Architect's Supplemental Instructions

Architect's Project No:
04561.01

Architect's ASI No: 025

See attached Exhibit A, and the above sheet list for rooms and locations of the point-of-use ANT, acid vent routing, piping diagrams, risers and acid vent through the roof locations.

PLUMBING WASTE AND VENT RISERS FOR PLUMBING RISER PR-4

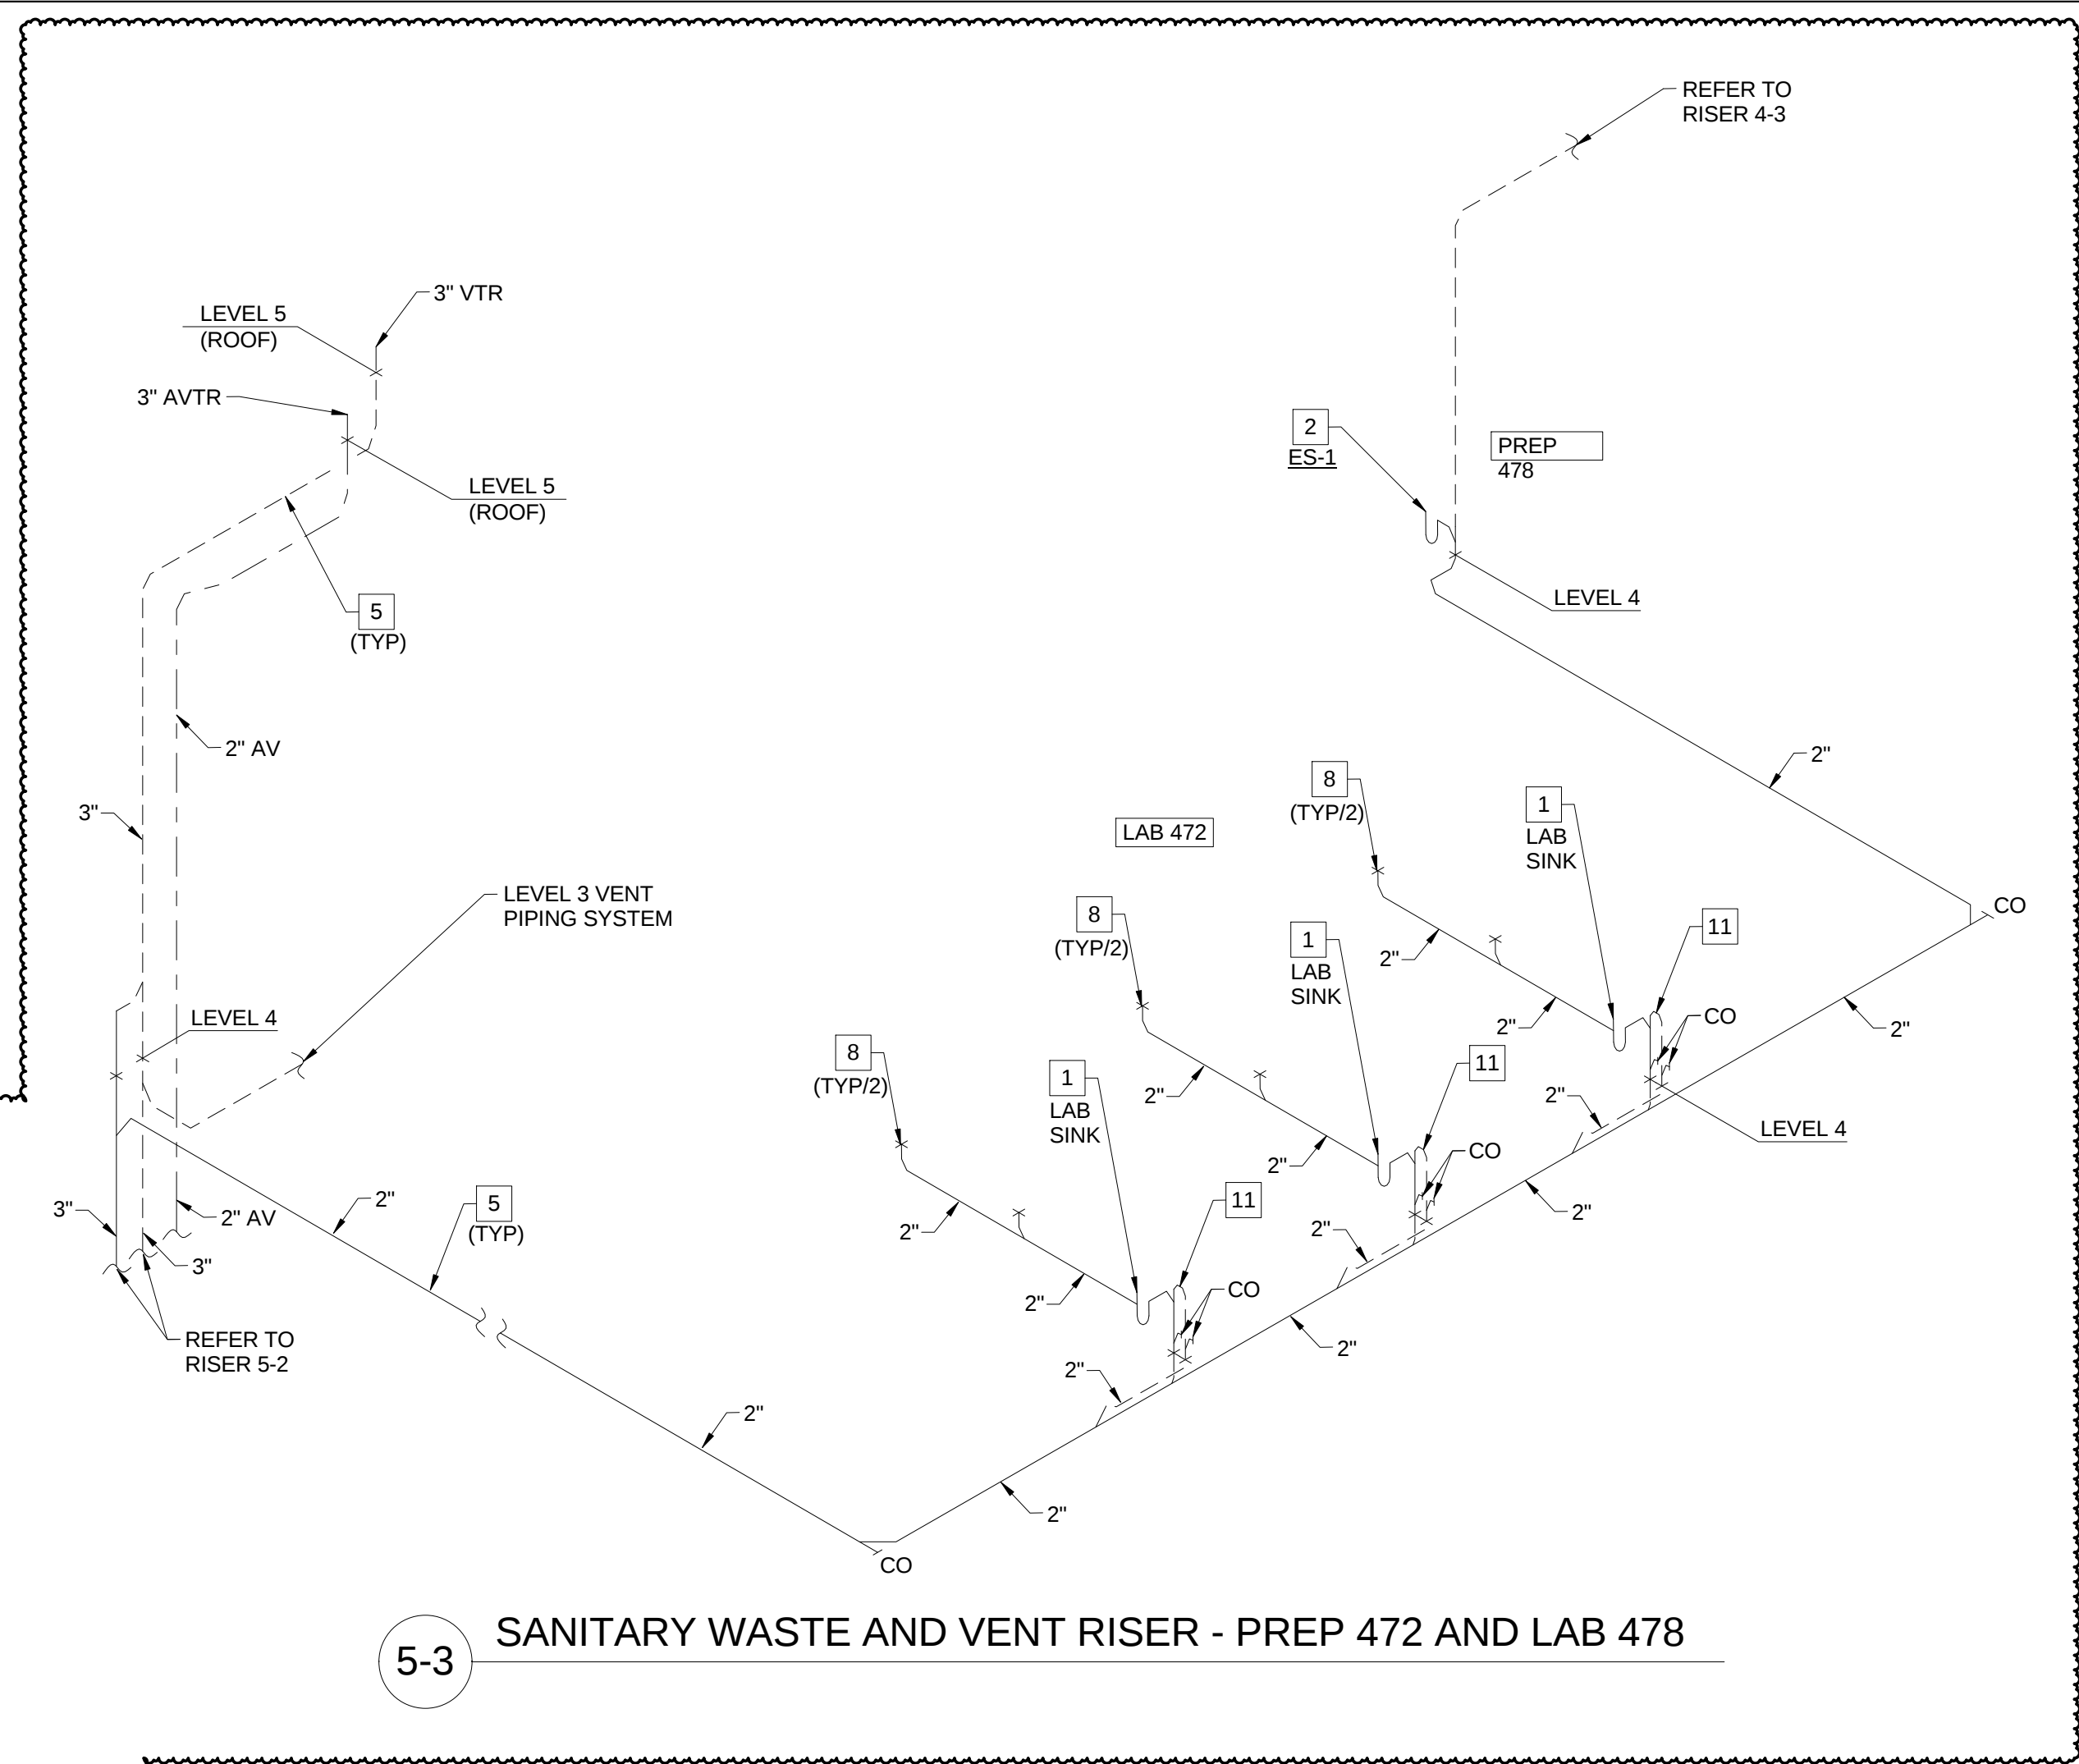
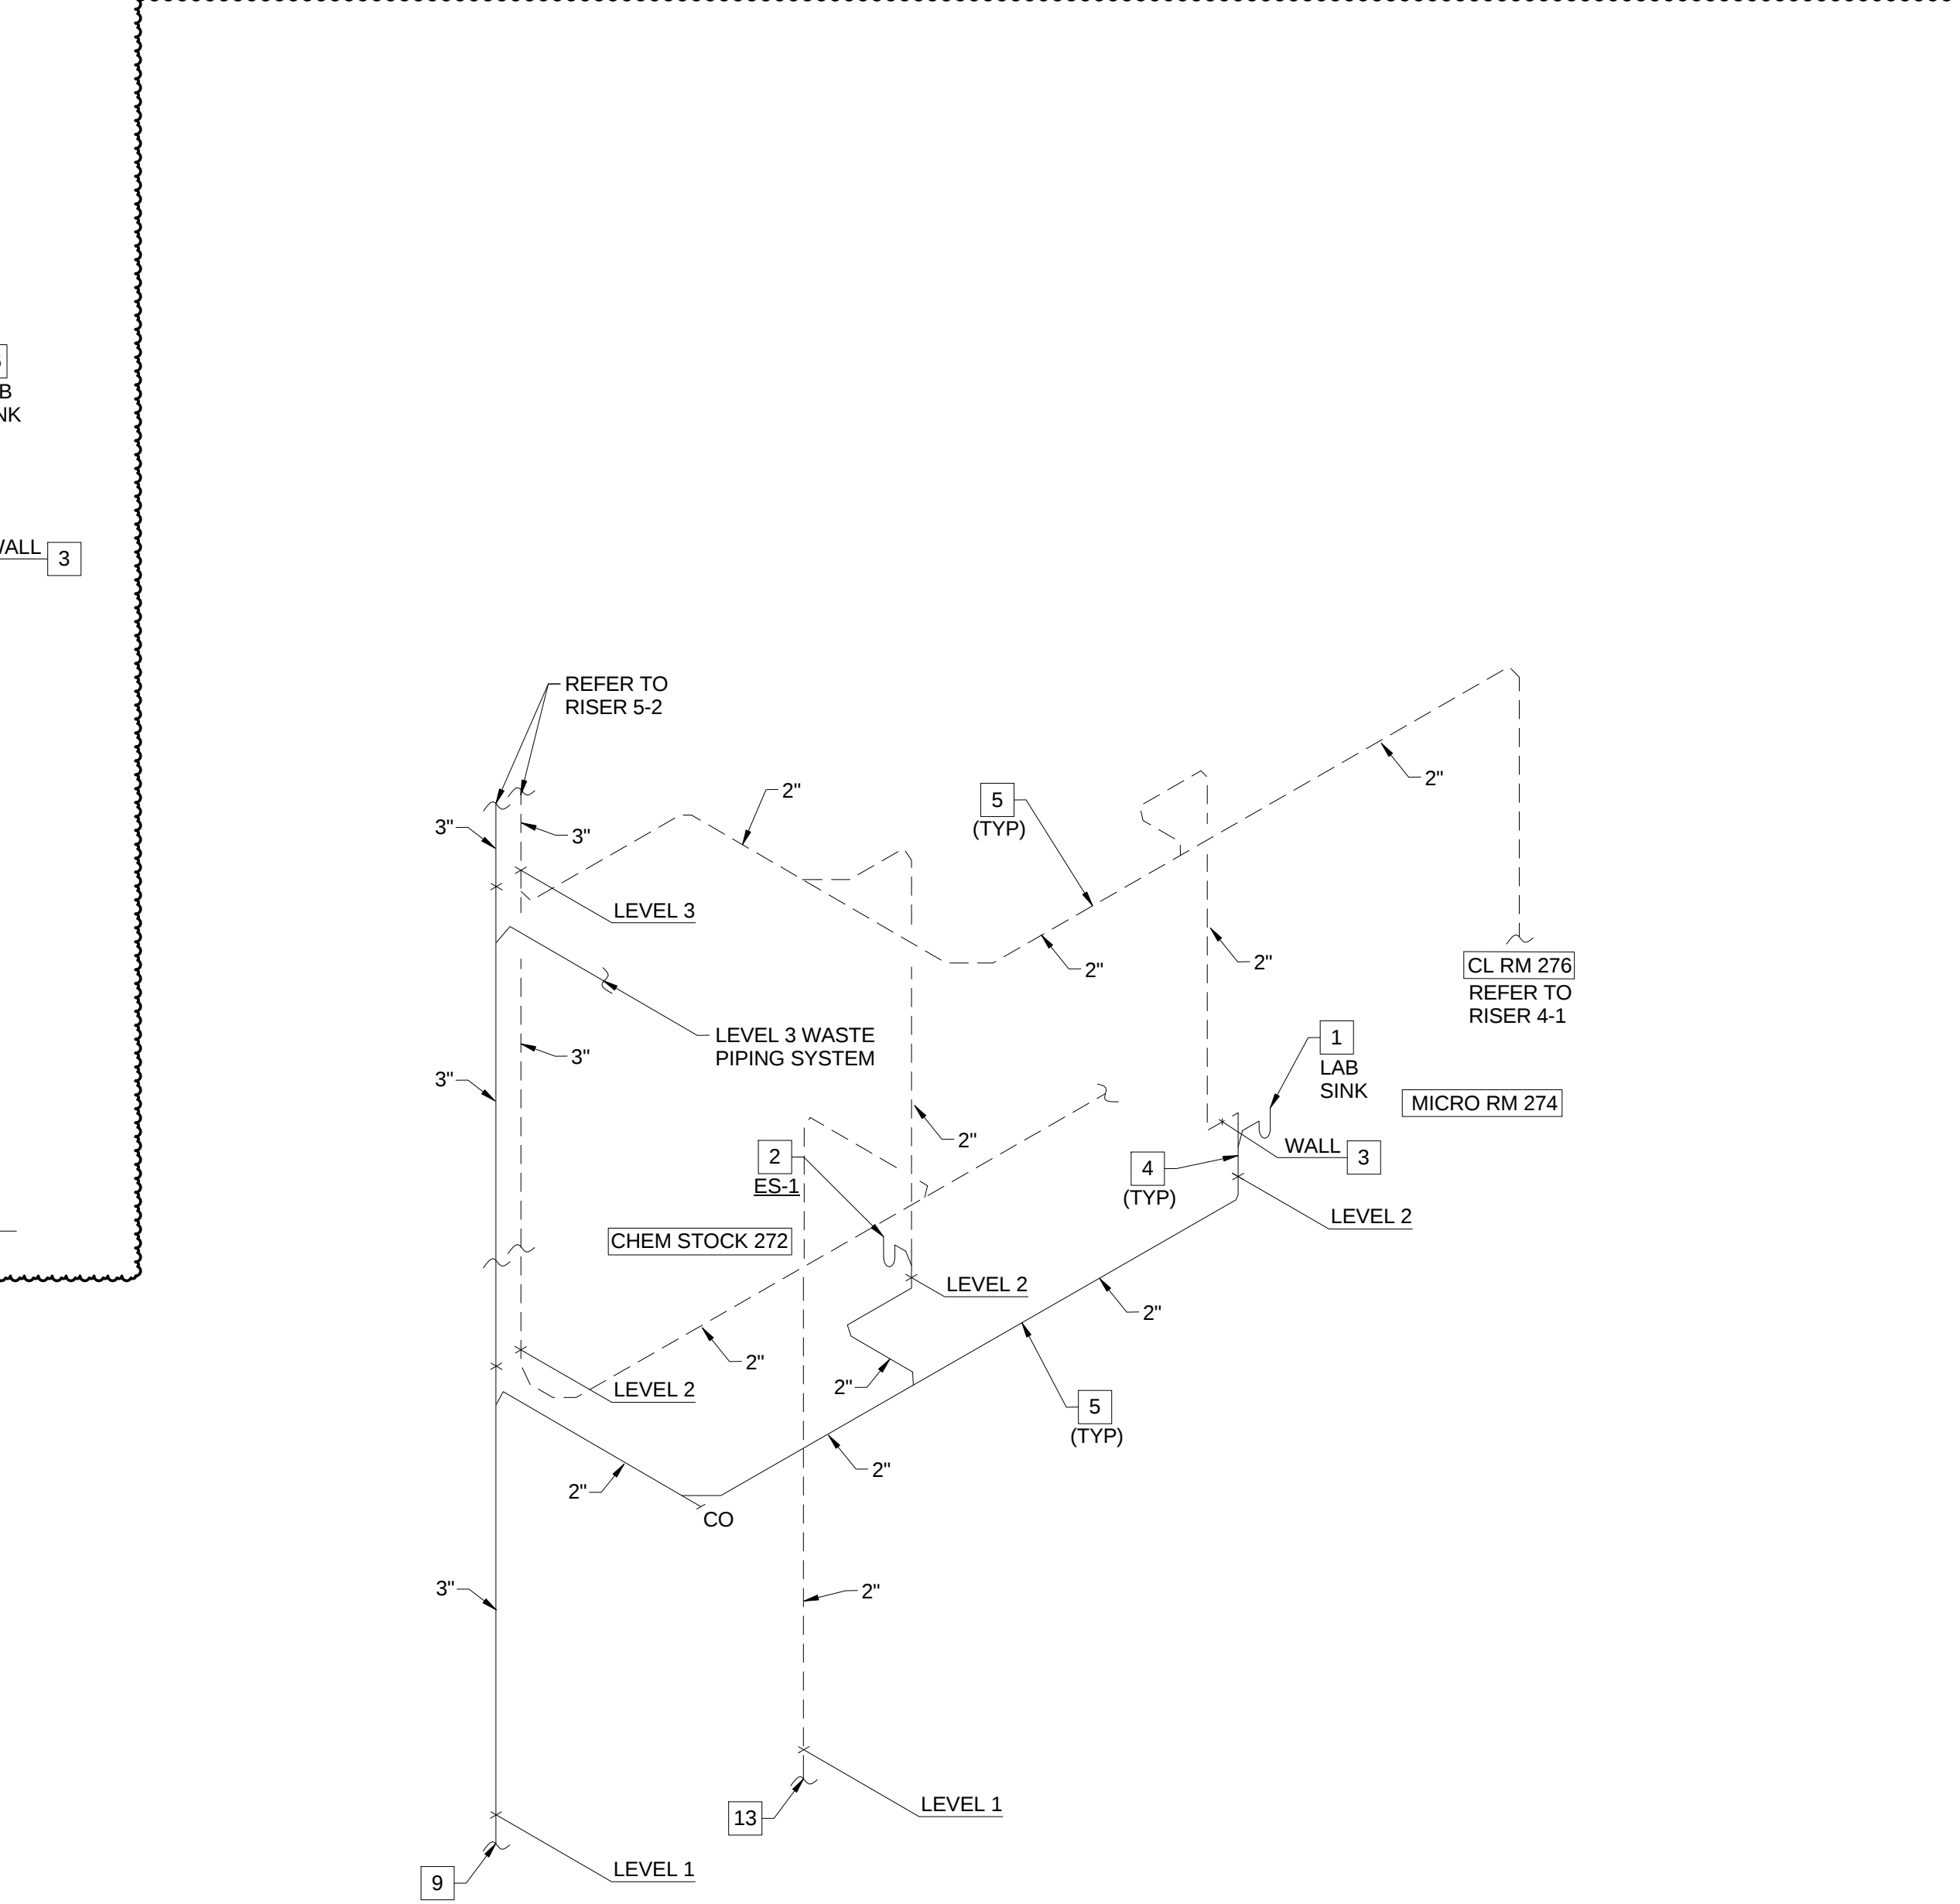
- 14 LAB SINK TO BE CONNECTED TO POINT-OF-USE NEUTRALIZATION TANK REMOTE FROM THE SINK LOCATION. COORDINATE WITH THE ARCHITECTURAL DRAWINGS FOR THE CASEWORK. REFER TO DRAWING P0404, DETAIL 1/P0404 FOR TYPICAL PIPING DIAGRAM. PIPING TO BE ADJUSTED AS REQUIRED FOR EACH LOCATION.

- 15 POINT-OF-USE NEUTRALIZATION TANK. COORDINATE LOCATION AND PLACEMENT WITH WITH CASEWORK. CONSIDERATION SHALL BE GIVEN FOR SERVICE AND MAINTENANCE ACCESSIBILITY.

- 16 LAB SINK AND GLASS WASHER TO BE CONNECTED TO POINT-OF-USE NEUTRALIZATION TANK REMOTE FROM THE SINK LOCATION. COORDINATE WITH THE ARCHITECTURAL DRAWINGS FOR THE CASEWORK. REFER TO DRAWING P0404, DETAIL 1/P0404 FOR TYPICAL PIPING DIAGRAM. PIPING TO BE ADJUSTED AS REQUIRED FOR EACH LOCATION.
